Independent International Panel of Experts for Flood Studies of Inland Rail in Queensland

Draft Report on Review of Helidon to Calvert Section

May 12, 2021

Figure 5: Gatton Local Model Interaction with Regional Model – Local Model 1% AEP Impact Results

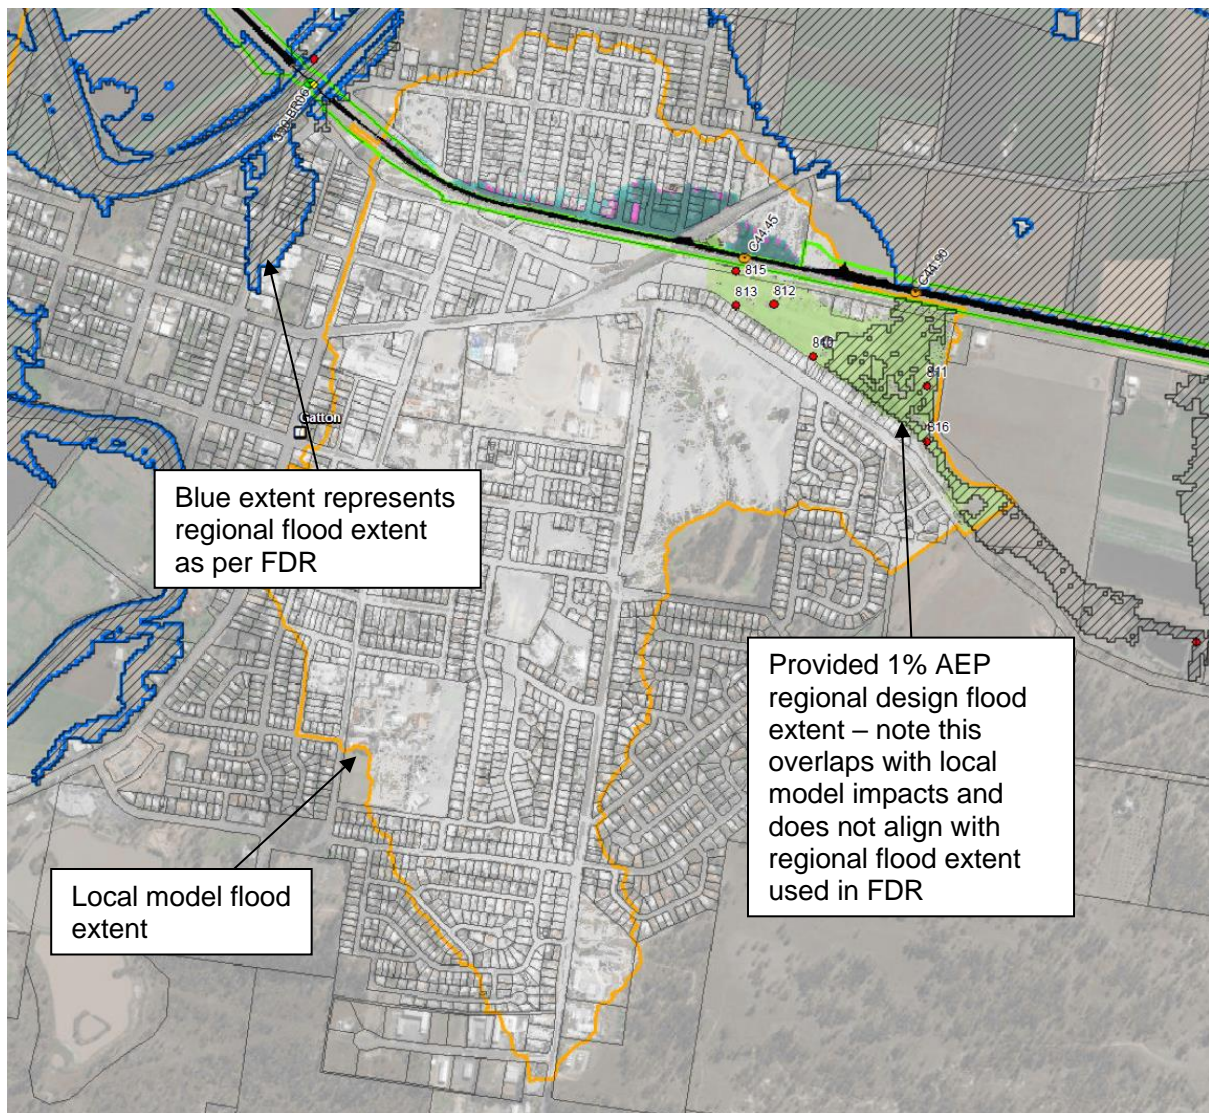
For example: the interaction between the local and regional flooding at Gatton is presented in Figure 5. It is unclear if the local model incorporates inflow from the regional model. Additionally, the regional flood extent (represented in blue) has not been represented on the eastern side of the model where impacts in the local modelling are noted. Figure 6 represents a similar scenario, but in reverse, where the local flood model extents are not represented in the regional modelling. Furthermore, the local model has been terminated in this area upstream of the Valley Vista estate where there is a documented history of flooding. LVRC local flood extents demonstrate the expected 1% AEP flood extent in this area and have been overlaid against local and regional flooding and presented in Figure 7. This shows a reasonable correlation between the ARTC local modelling and LVRC local model, but there is a clear disparity between the regional flood extents. This has the potential to result in underestimated impacts surrounding the rail alignment.

The flood interaction issues were raised by the Panel with FFJV on the 25/03/2021 with a Technical Note response provided on the 31/03/2021. This Technical Note identified that the local model at Gatton was a direct rainfall model with a significantly shorter critical duration (than the regional model). As such, a regional tailwater was

not applied. Additionally, it was noted that the Laidley local model was developed with a discharge curve as a downstream boundary condition which result in a tailwater level several meters higher than the regional 1% AEP flood level from Lockyer Creek. Although both these justifications may be logical, neither demonstrates that the flooding (regional and local) is independent of one another and can be assessed in this manner. Furthermore, the issue of flood representation in the Valley Vista estate area has not been addressed. Therefore, further documentation and potential sensitivity modelling to ensure flood impact objectives are met is required with respect to the incorporation and assessment of flood interaction between the local and regional models.

Figure 8: Downstream Boundary Configuration with PMF Flood Extent

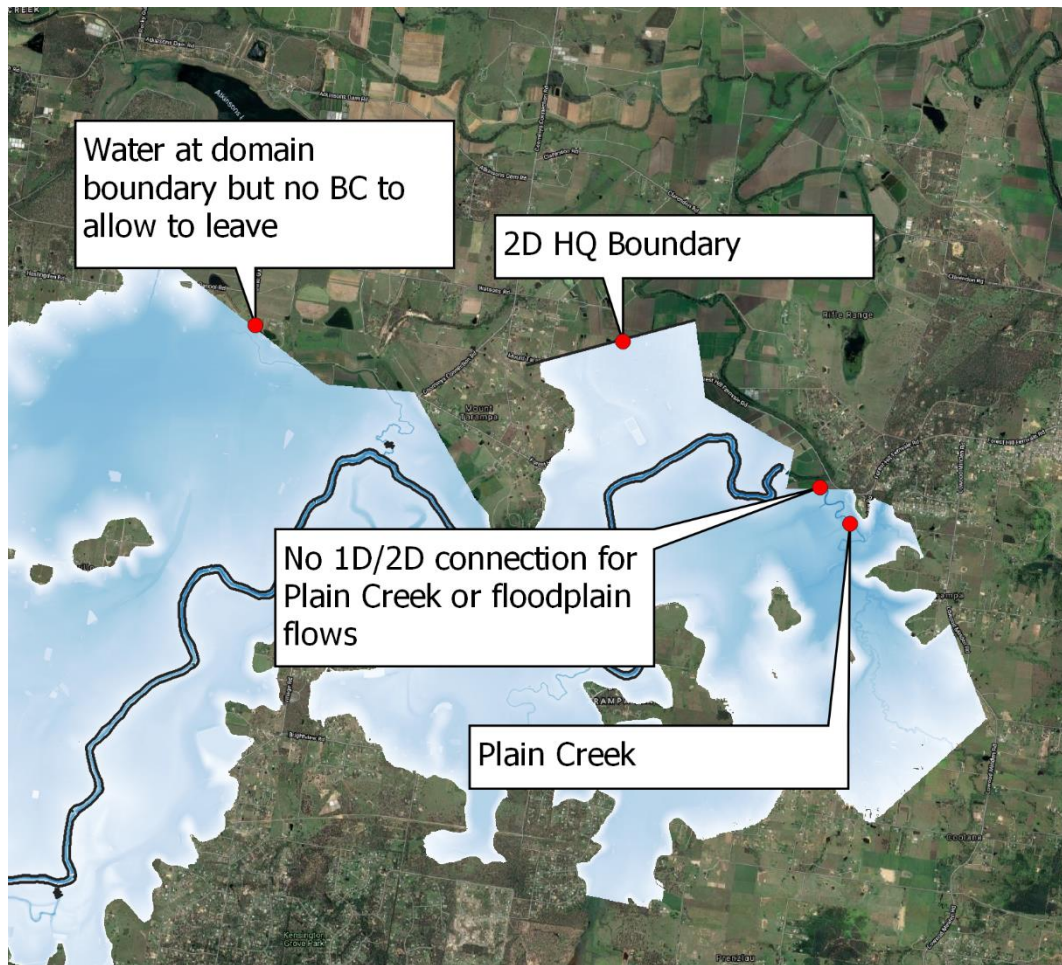
Figure 8 shows the configuration of the downstream boundaries overlaid with the PMF flood extents. The 1D downstream boundary is not located at the downstream end of the 2D model domain and as such, flows in the floodplain or from Plain Creek are not able to exit the model via the boundary. This is unlikely to have impact at the rail alignment but it is recommended that in future project stages the boundary is moved downstream of Forest Hill Fernvale Rd and additional 1D/2D connections are added.

The 2D HQ downstream boundary allows flow to exit the model to the north of Lockyer Creek. However, there is still a significant amount of water ponding against the model boundary in extreme events, as shown in Figure 8.

Figure 9: 1D/2D Connection Issue

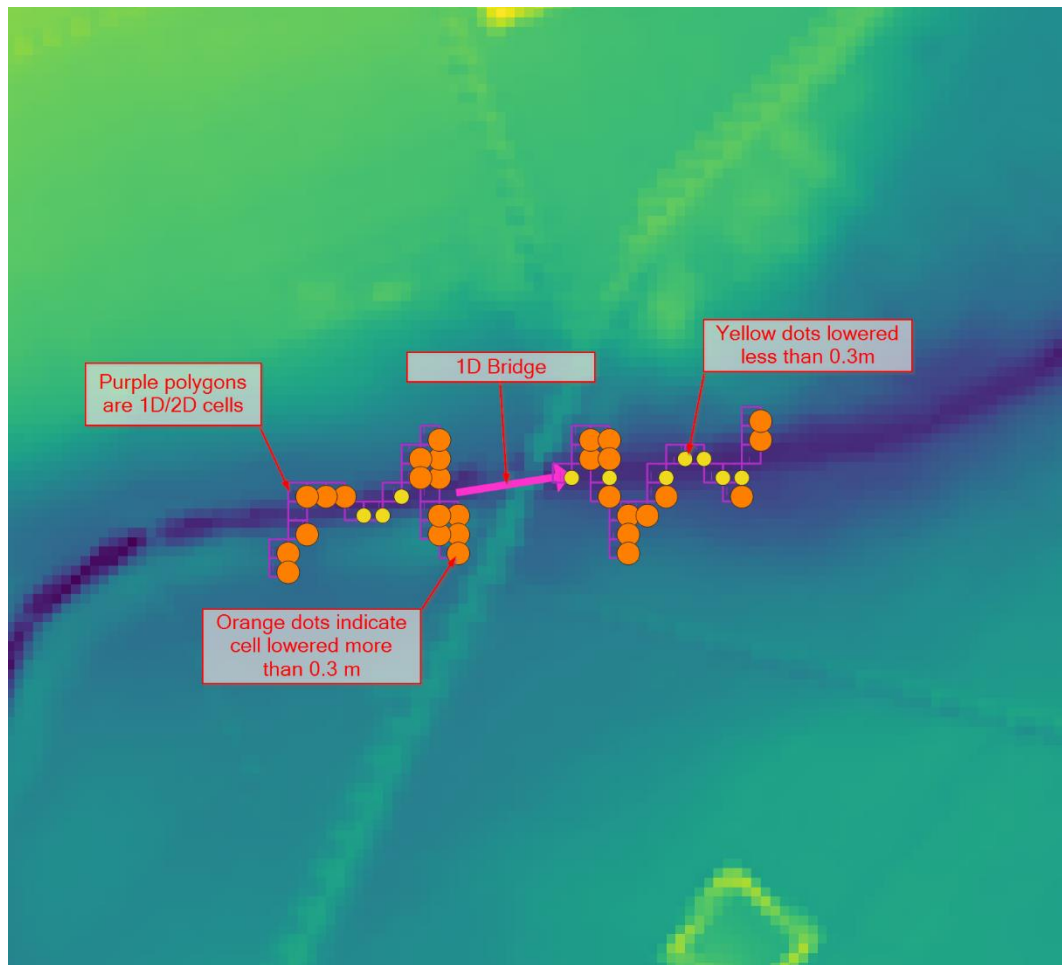
There are noted connection issues with culverts throughout the model where culverts are overconnected (connected to a significantly higher number of cells compared to the structure width) and artificial lowering of cells is being applied. An example of this is presented in Figure 9. The orange dots indicate that the elevations have been lowered by more than 0.3 m. The rectangular culvert in this situation is 28 m wide and should be connected to approximately 3 (10m) cells on the upstream and downstream sides. However, the number of connected cells significantly exceeds this number. The connection has also been input using a “zig-zag” pattern, which generates significant artificial topographic changes.

Figure 10: 1D HX Connection Issue at Confluence Locations

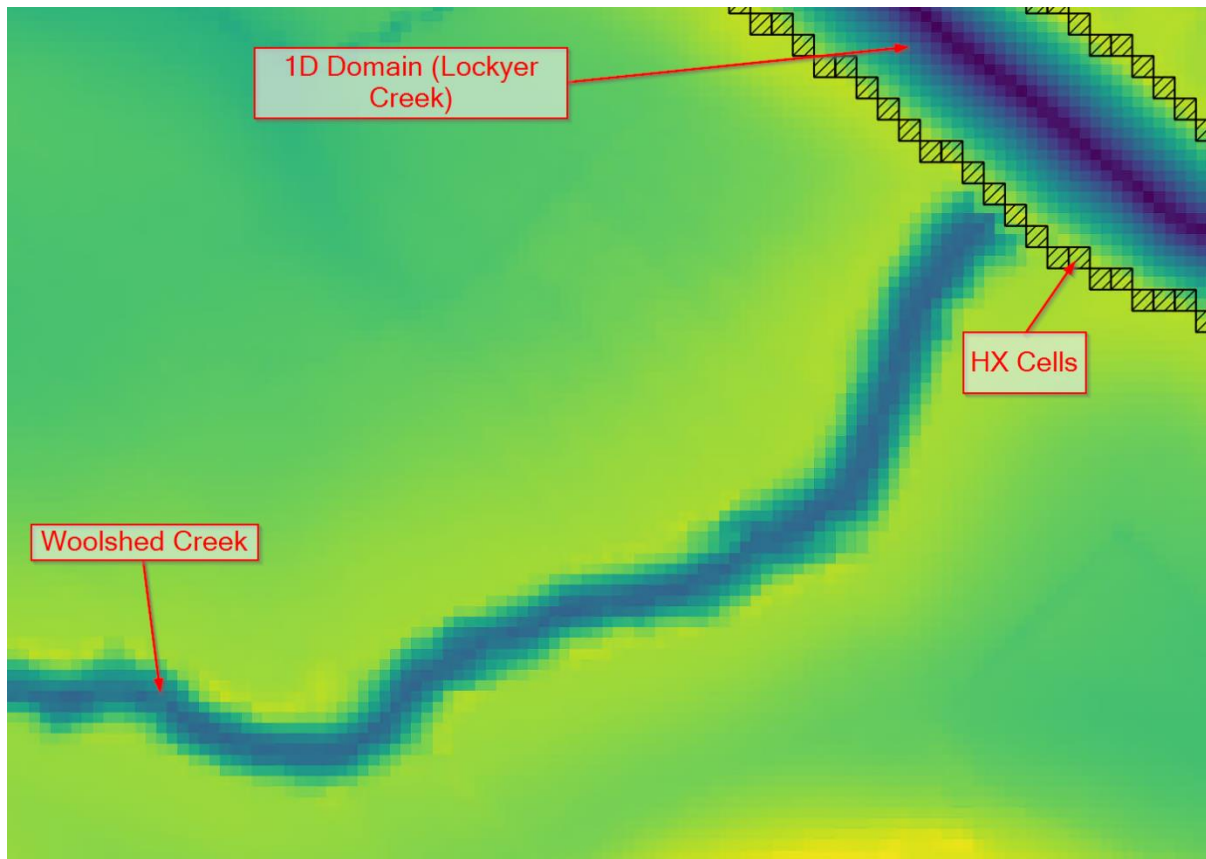
There are also reoccurring issues at the 1D waterway confluence points throughout the model. Figure 10 demonstrates this issue occurring at the confluence of Woolshed Creek and Lockyer Creek. The connection cells have high elevations across the incoming creek hindering water from flowing from the unnamed creek into Lockyer Creek. Understanding that Lockyer Creek is a perched waterway, the model should correctly represent the tributary connections by lowering the cell(s) at confluence locations throughout the model.

Figure 11: 1D/2D Connection Issues at Laidley Creek and Sandy Creek Confluence

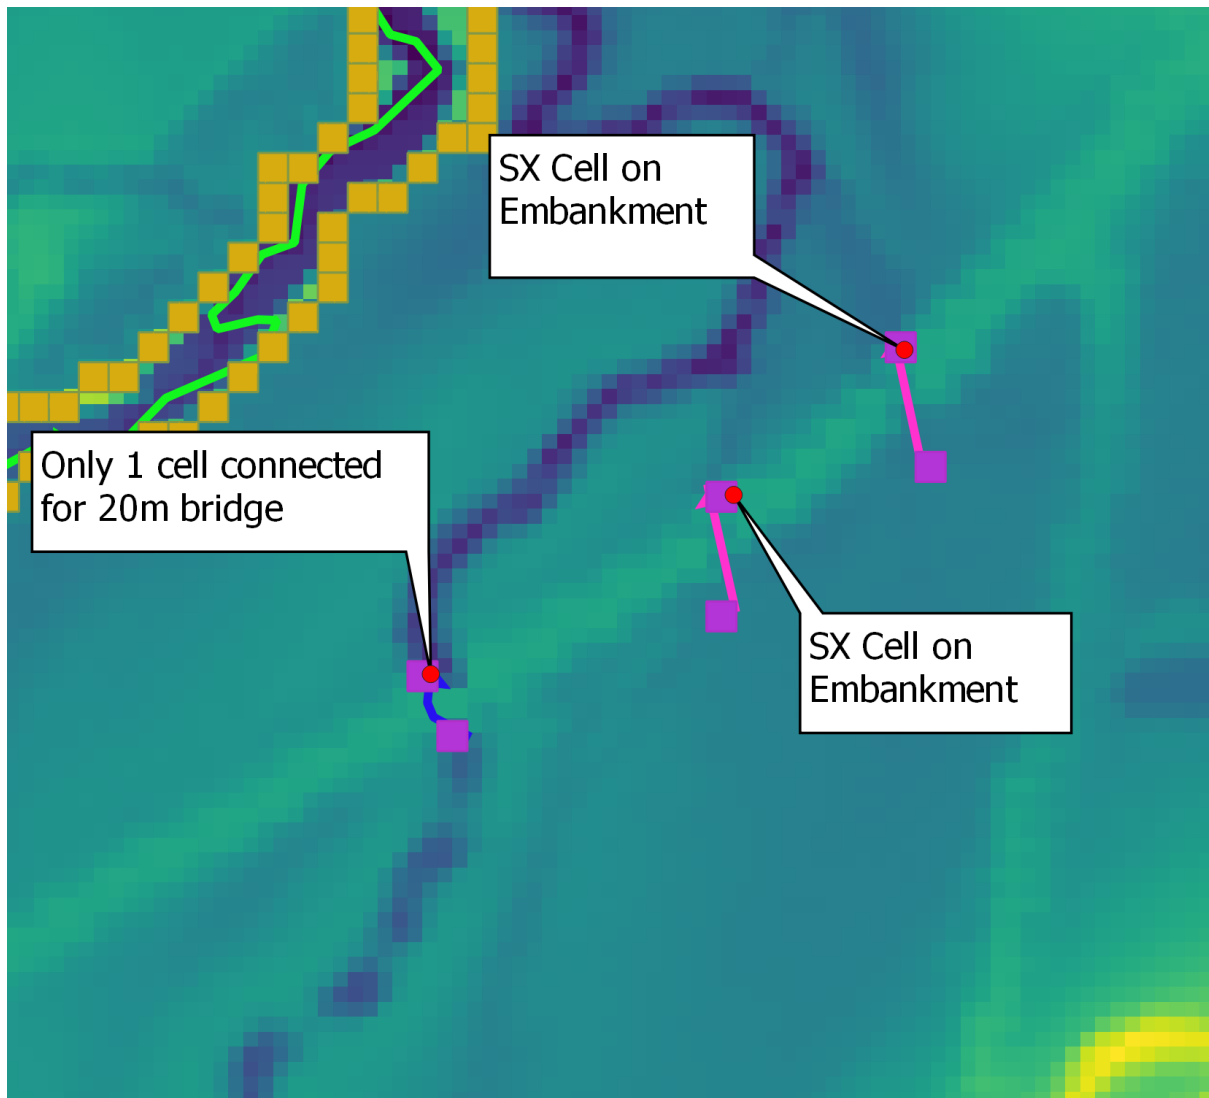
There are multiple issues identified in the area where Sandy Creek meets Laidley Creek as shown in Figure 11. These issues are not limited to this location; similar issues have been identified in other areas of the model. The issues identified are:

- Connection issues at the 1D bridge for Laidley Creek
 - The bridge is modelled as 20m wide (as per TUFLOW check file) but is only connected to one 10m cell on the upstream and downstream sides of the bridge.
- 1D/2D culvert connection issues
 - Two adjacent culverts have SX cells which are connected to cells situated on top of the embankment. These should be connected north of the embankment.

The identified issues, which are shown on Figure 8 to Figure 11, are not isolated issues and are prevalent throughout the model extent. The identified issues are unlikely to have significant bearing on the overall model results. However, they may undermine confidence in the modelling approach and be addressed in future project stages.

Figure 12: 1D Network Issues at Downstream End of Ma Ma Creek

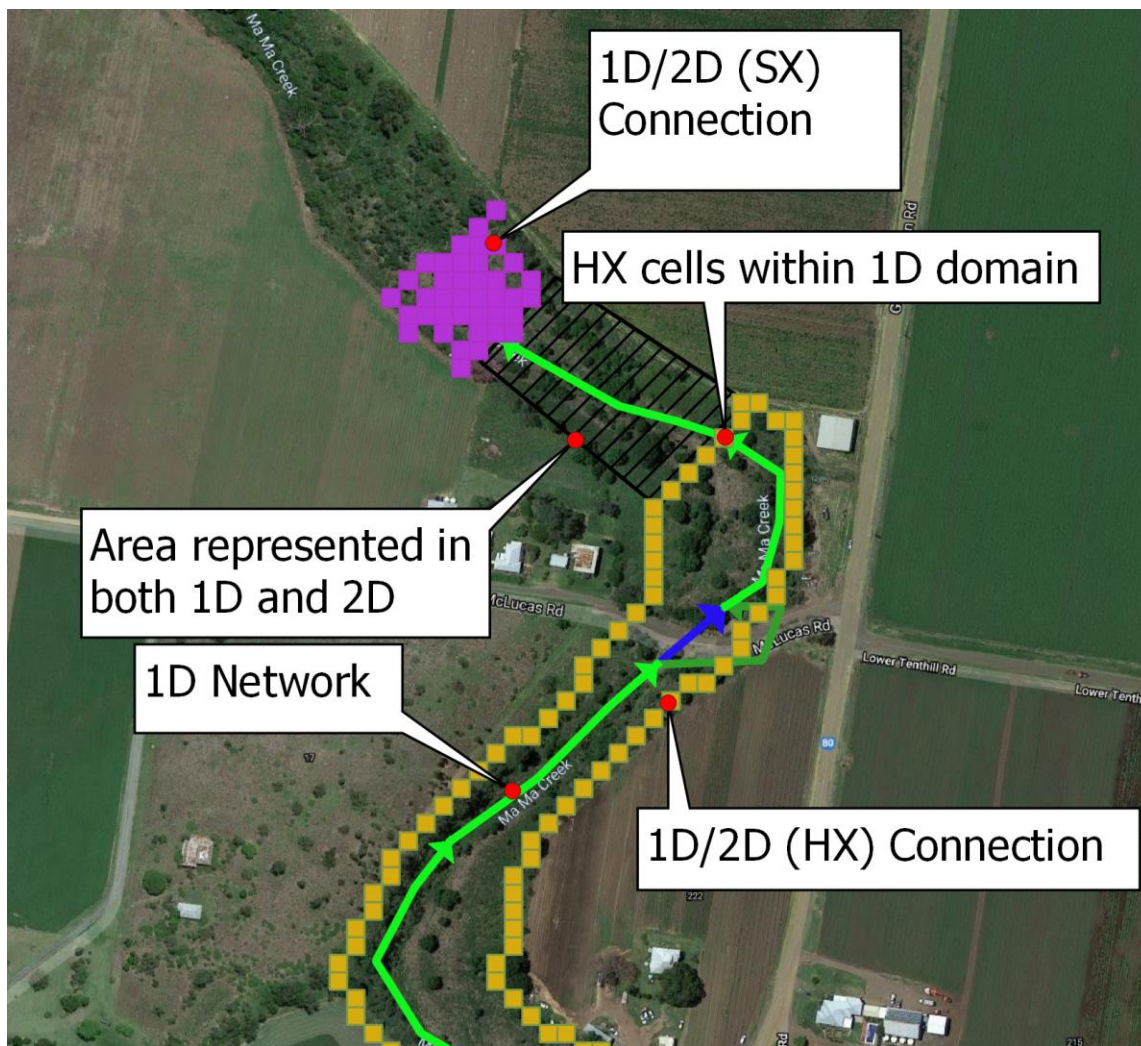
There are several connection issues identified at the downstream end of Ma Ma Creek as presented in Figure 12. The current model setup (1D/2D boundaries) is configured so that there are areas represented in both 1D and 2D. This area should be reconfigured to eliminate duplicate representation and isolated 2D cells.

Figure 13: Connection Issues Deep Gully and Tenthill Creek Confluence

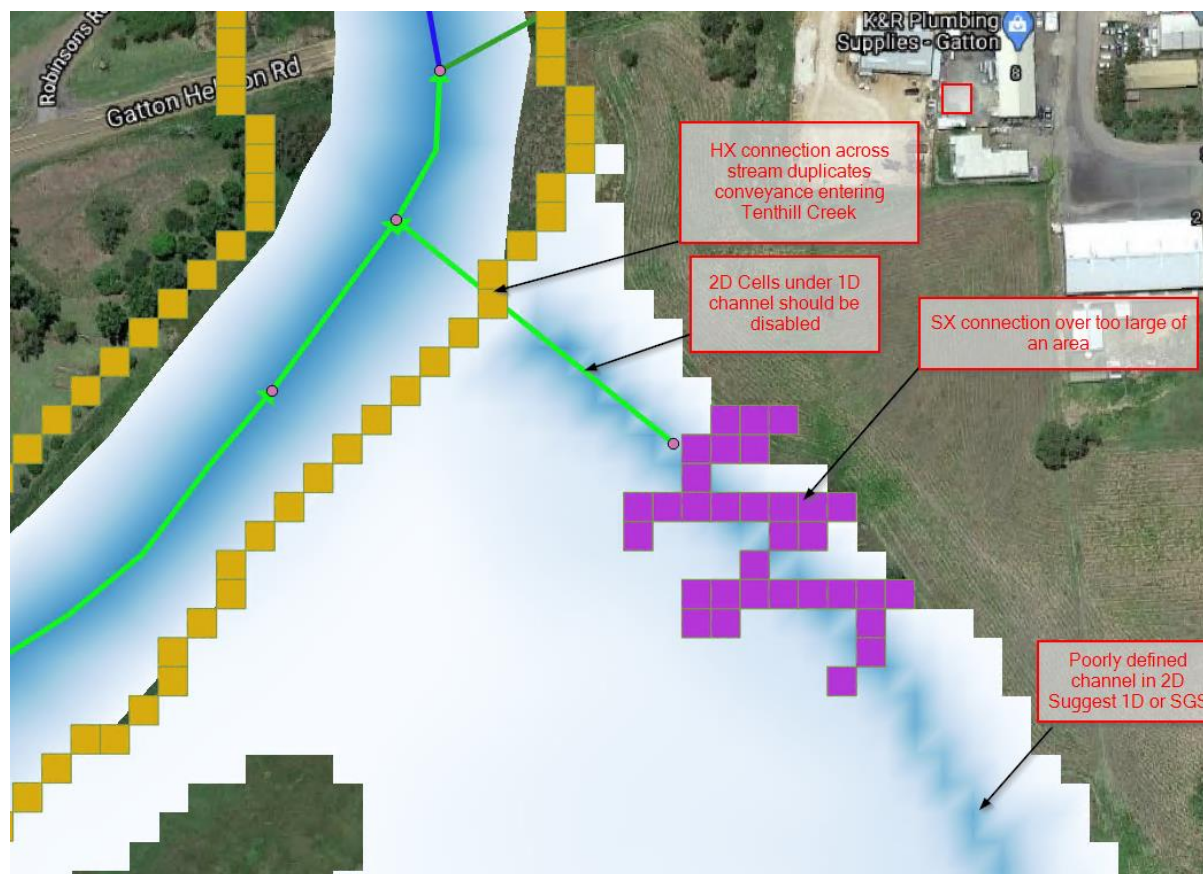
Connection issues have been identified at the Deep Gully and Tenthill Creek confluence point as shown in Figure 13. The connection between Deep Gully and Tenthill Creek is duplicated with two methods being applied (both HX and SX connections used). Furthermore, Deep Gully is poorly represented in the model (represented in 2D) which may impact the potential conveyance of the waterway. Additionally, similar to the issue previously identified, the SX connection covers an area much larger than is reasonable.

Figure 14: Missing Culvert Structure

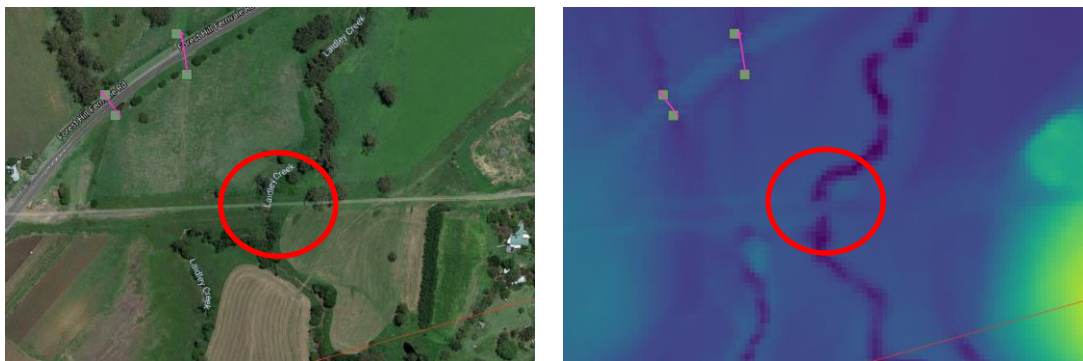
There is limited documentation included in the Technical Report addressing the inclusion of existing hydraulic structures within the model extent. The model incorporates approximately 138 cross drainage structures which are located throughout the model extent. Preliminary review of the modelling indicates that several minor waterway crossing culverts are not included in the modelling. An example of this the Laidley Creek crossing upstream of Forest Hill Fernvale Road as shown in Figure 14.

The identified missing culvert infrastructure is generally situated on minor waterways and is unlikely to significantly impact large flood events such as the 1% AEP. As such, the impact may only be to minor events and unlikely to have significant bearing on the current model results. However, it is recommended that a review of missing culvert infrastructure be undertaken in the next phase of the project to ensure that existing cross drainage infrastructure is included.
